ADDENDUM NO. 1

February 16, 2024

Yorktown High School – Addition and Renovations 1100 South Tiger Drive Yorktown, IN, 47396

ADDENDUM

DRAWING NUMBER A201J

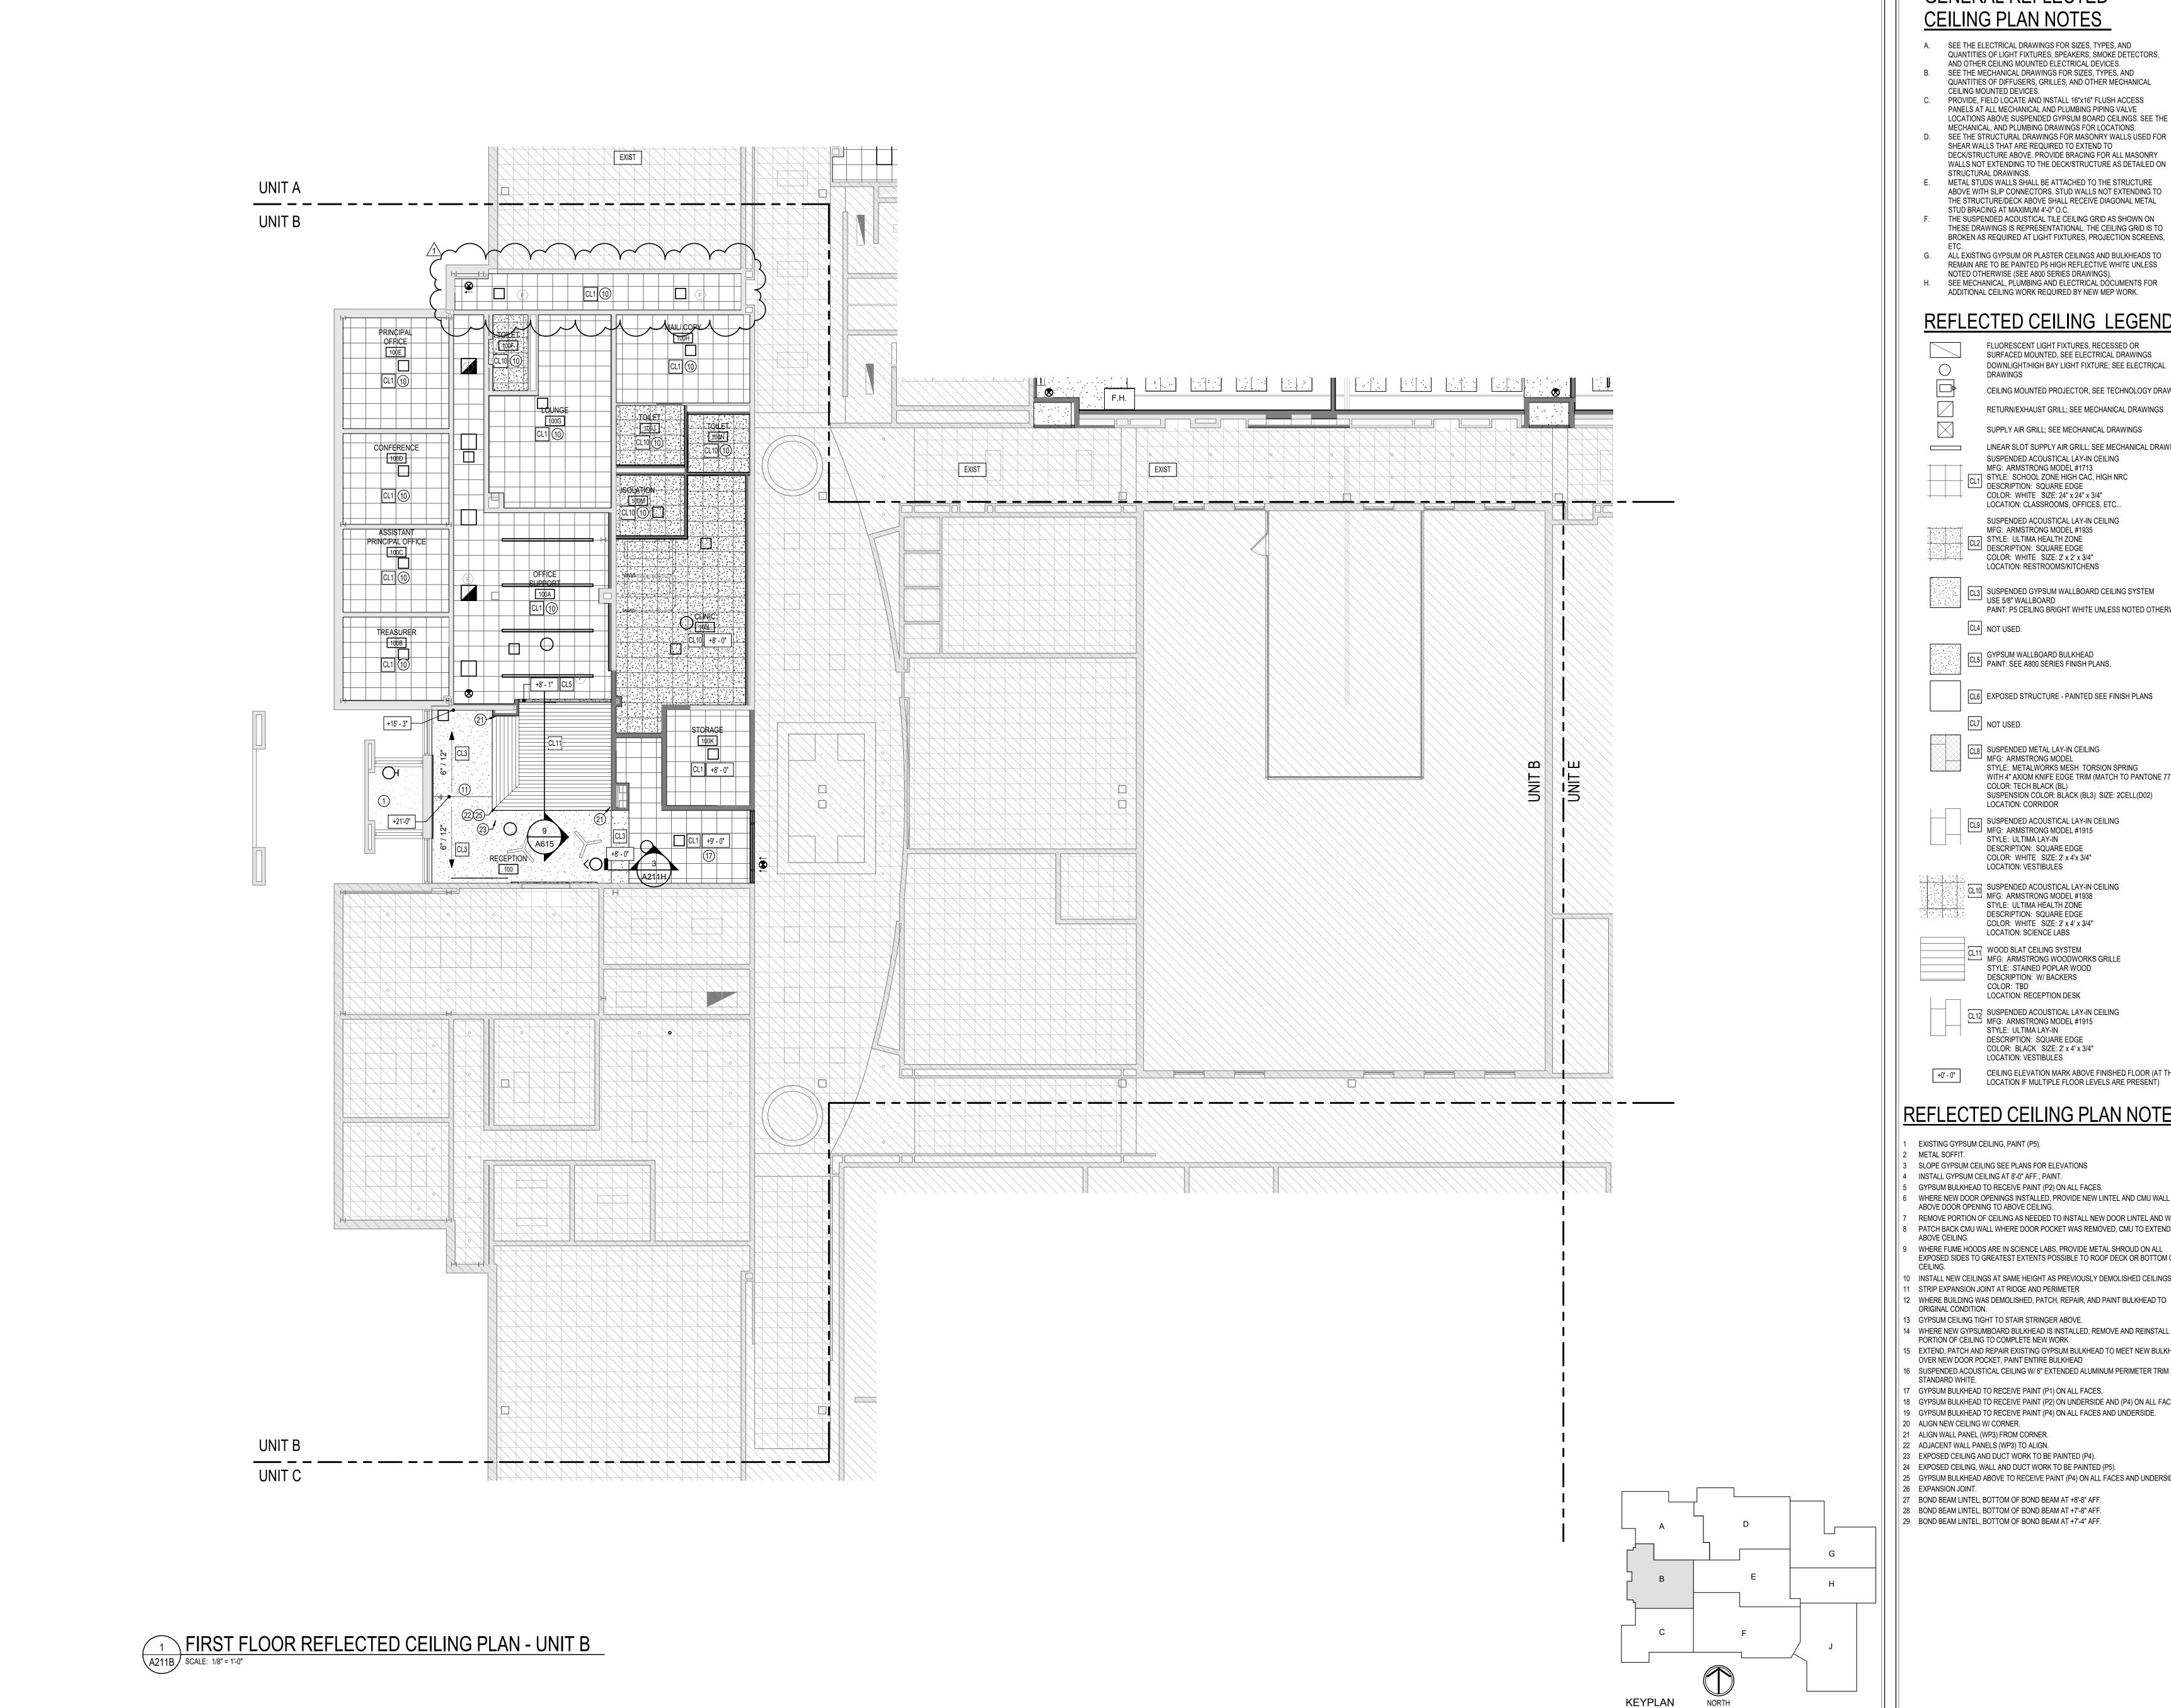
3.13 A201J – FIRST FLOOR PLAN – UNIT J

- A. Revise Weights & Conditioning 900 south wall. The South wall shifted south **+/- 10'-0"**. Platform 900A, Office 900B, Weights Storage 900C, Mechanical Access 900D, and Mechanical Mezzanine all shift accordingly.
- B. Revise layout for doors 901.1 and 901.2 as well as the TV feature wall as part of the Weights & Conditioning wall shift.
- C. Add fur out the South wall of Vestibule 12 with **W12.**
- D. Provide additional dimensions for graphical clarity and constructability around Vestibule 7 and door 9B.
- E. Add Plan Note #26 to Storage 704.

DRAWING NUMBER A211G PROJECT NUMBER

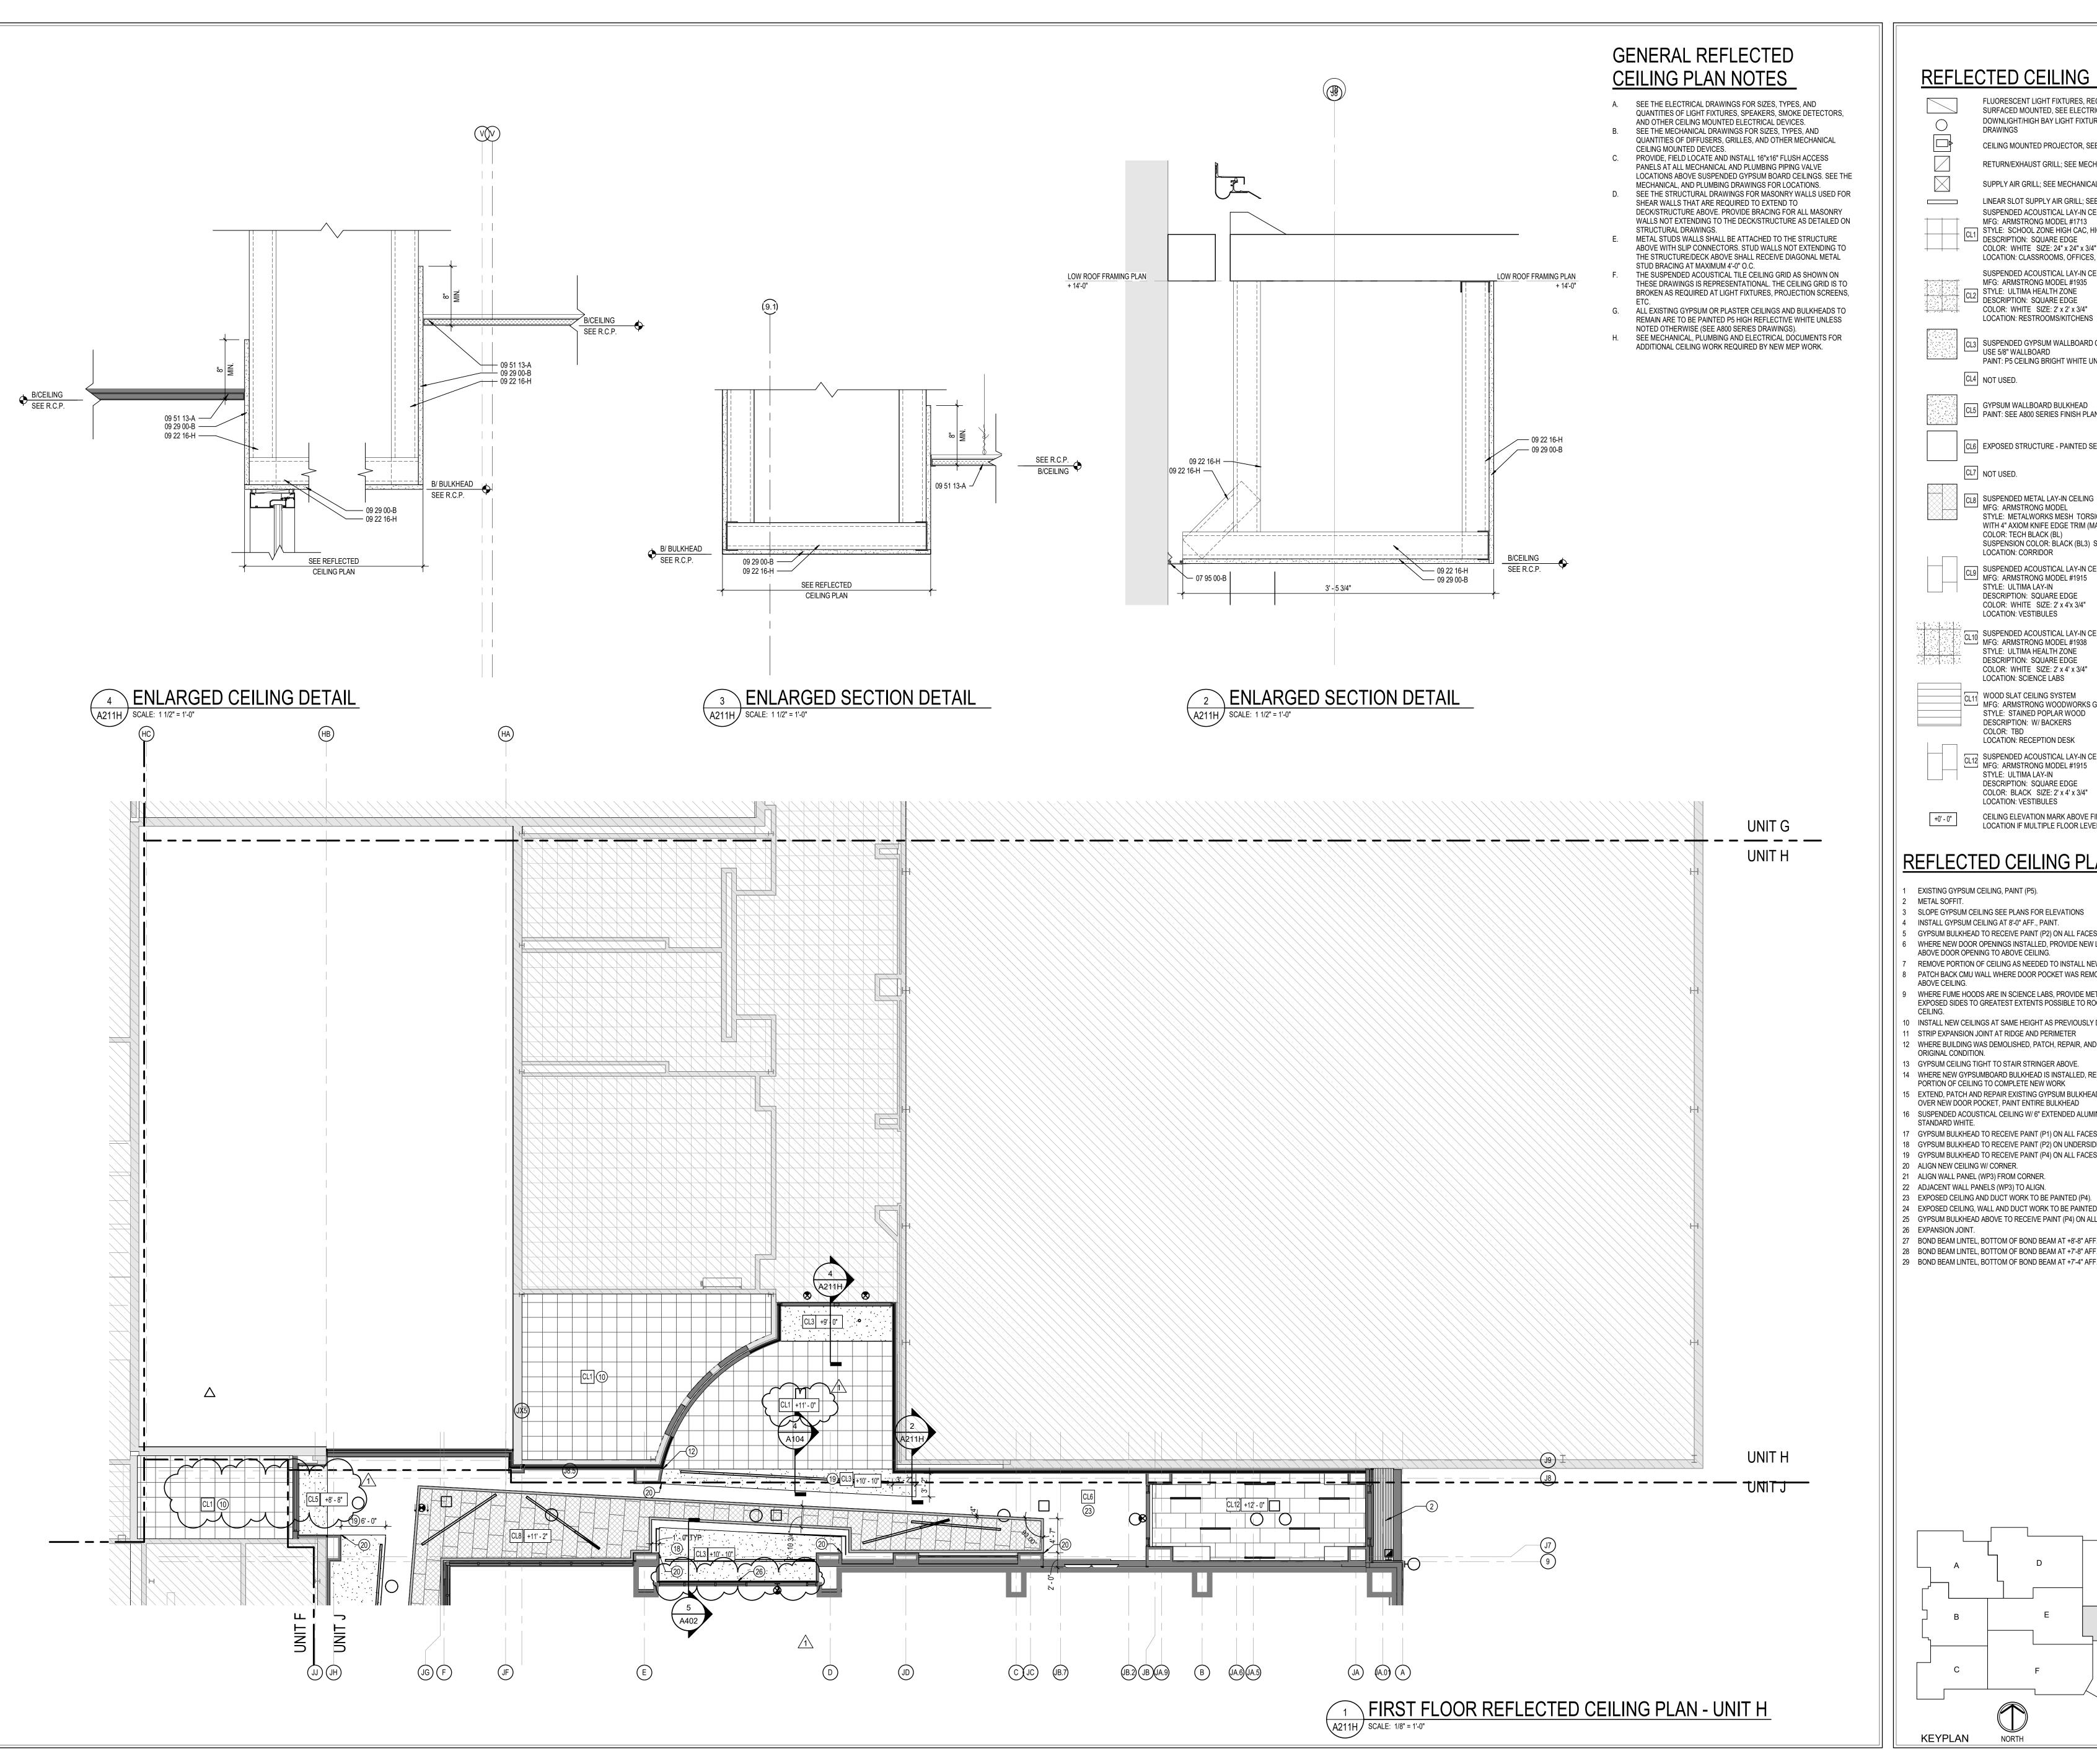
3.15 A211G – FIRST FLOOR REFLECTED CEILIGN PLAN – UNIT G

- A. Add Ceiling Note #27 BOND BEAM LINTEL, BOTTOM OF BOND BEAM AT +8'-8" AFF.
- B. Add Ceiling Note #28 BOND BEAM LINTEL, BOTTOM OF BOND BEAM AT +7'-8" AFF.
- C. Add Ceiling Note #29 BOND BEAM LINTEL, BOTTOM OF BOND BEAM AT +7'-4" AFF.
- D. Locate Ceiling Notes #27, #28, and #29.
- E. Tag Existing Ceiling in Storage room.
- F. Revise so all showers locker rooms have ceiling **CL5**.

DRAWING NUMBER A211H

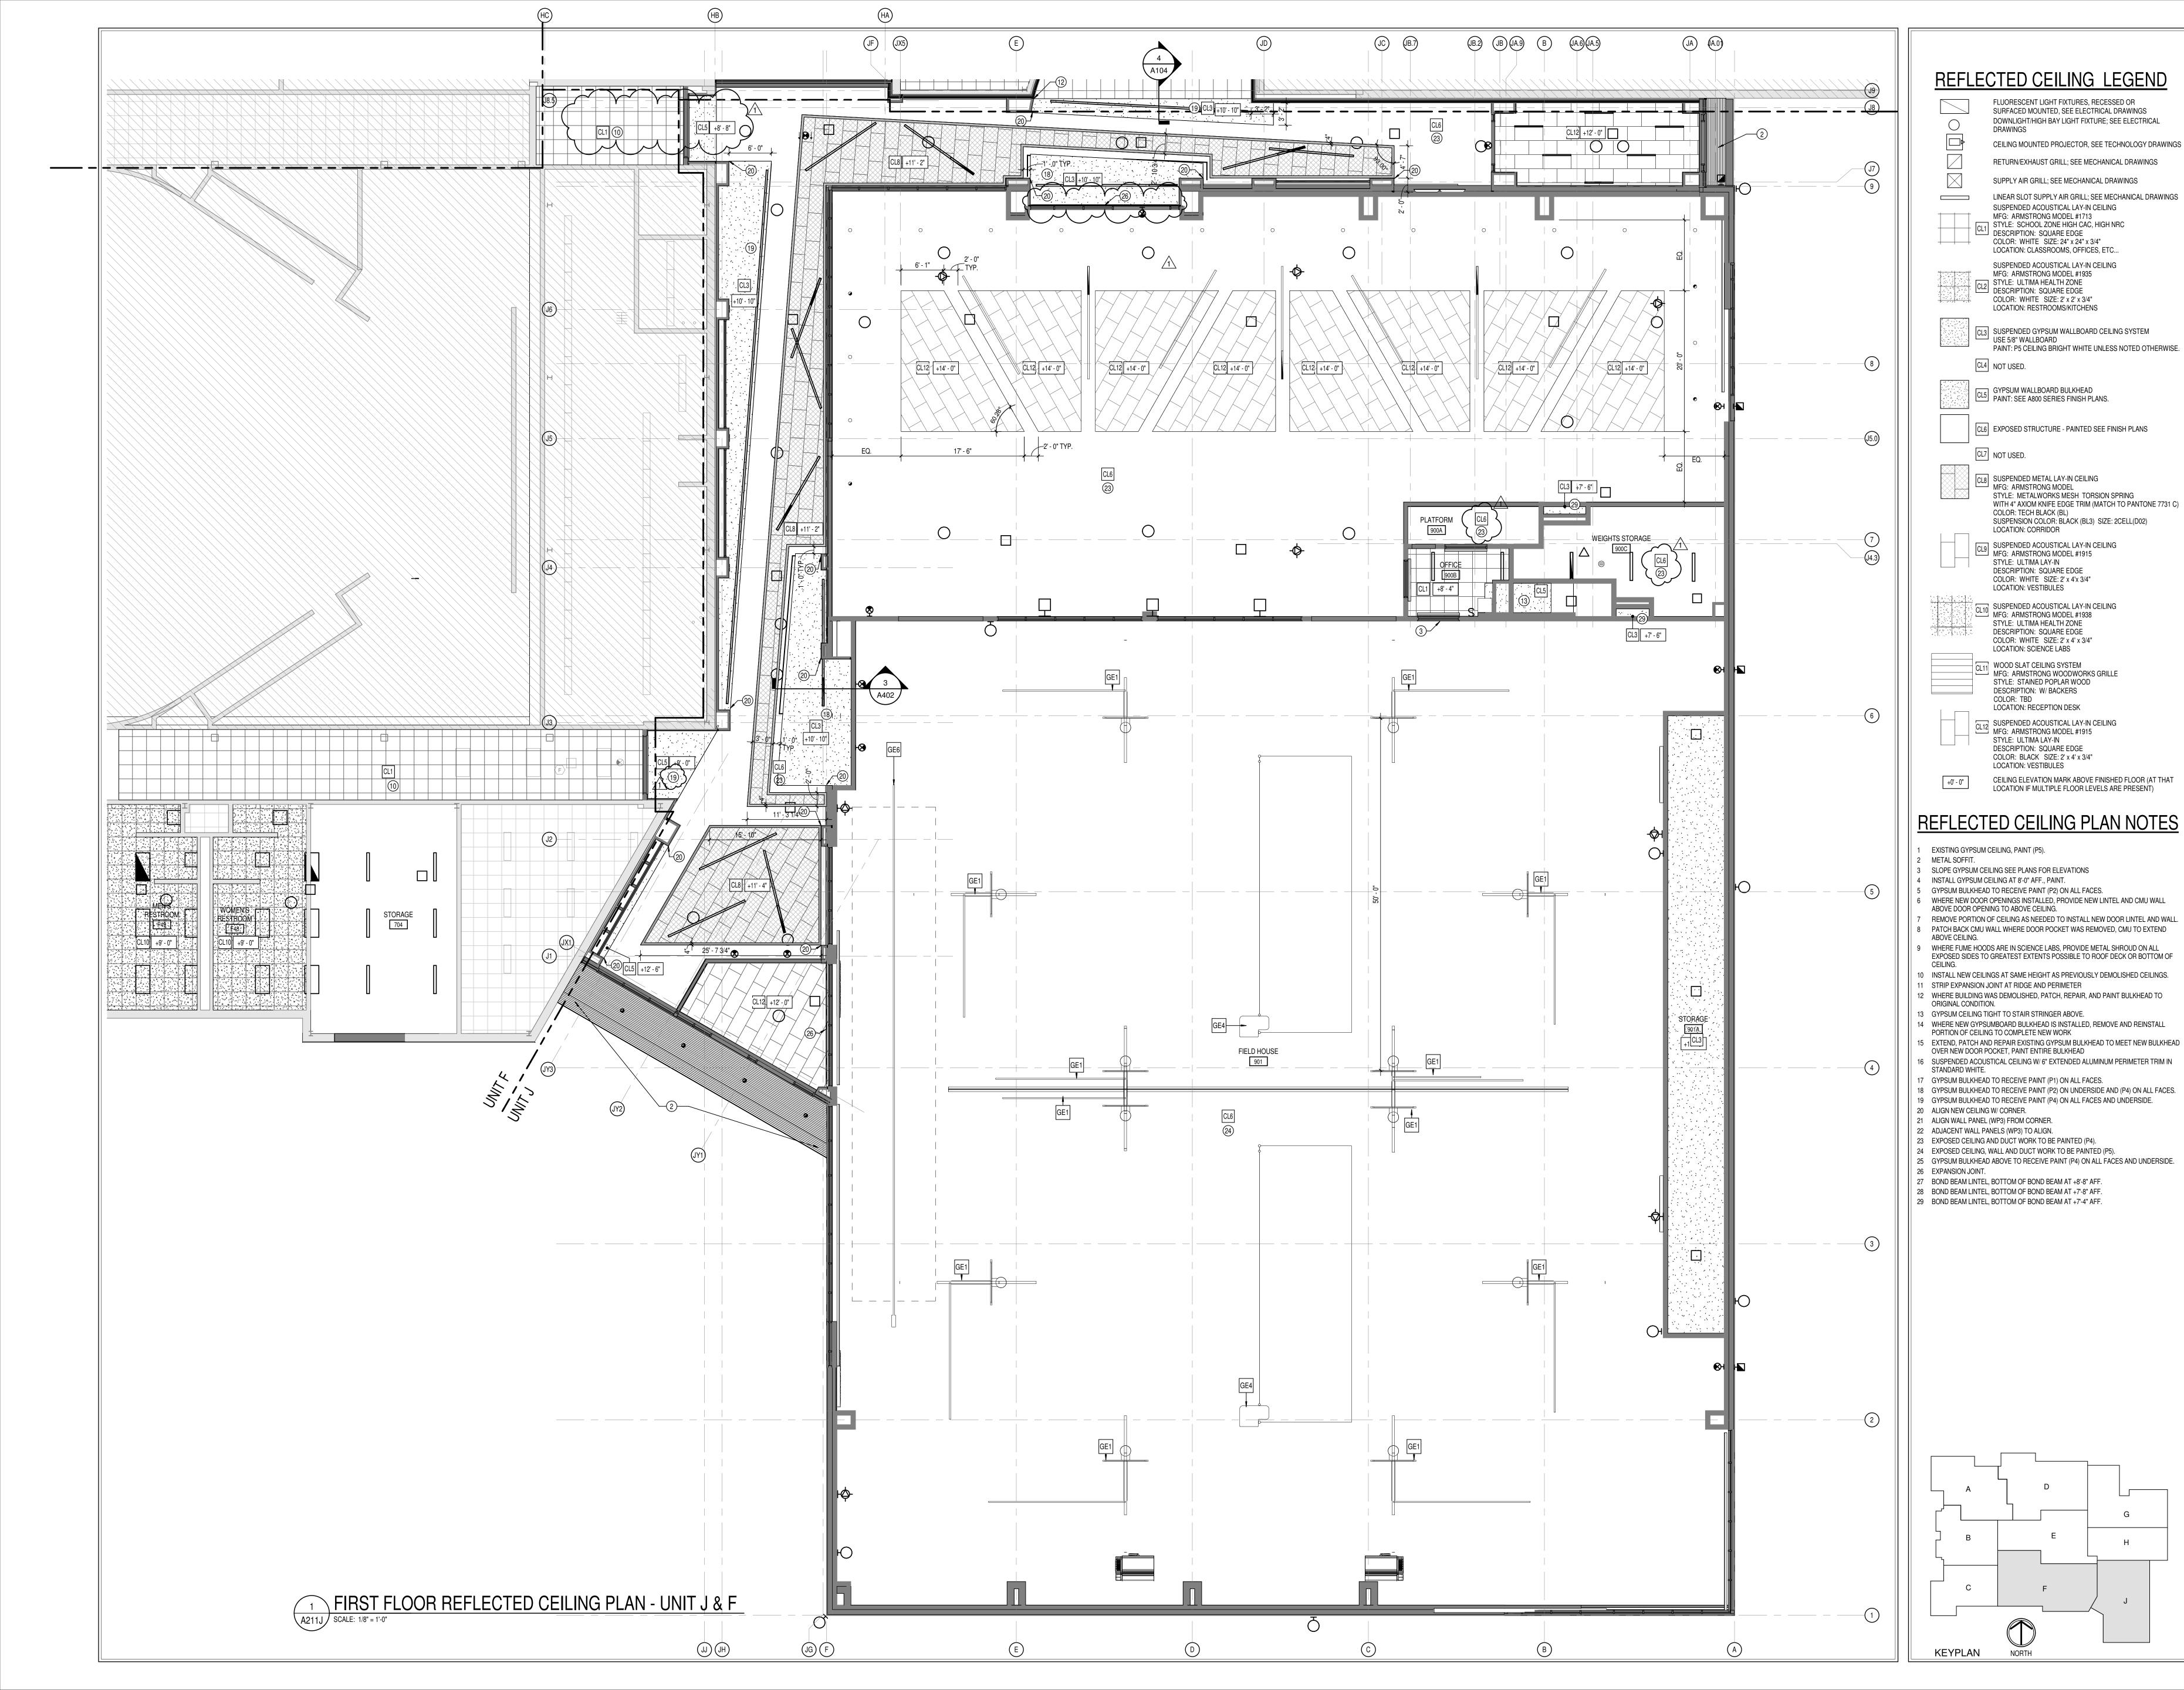
3.16 A211H – FIRST FLOOR REFLECTED CEILING PLAN – UNIT H

- A. Revise CL1 ceiling in Corridor 9 to be **11'-0"**
- B. Add CL1 in Concessions at same height as existing ceiling.
- C. Add CL1 in existing Vestibule at door 9A at same height as existing ceiling.
- D. Tag New Ceiling at door 9A as **CL5 at 8'-8".**
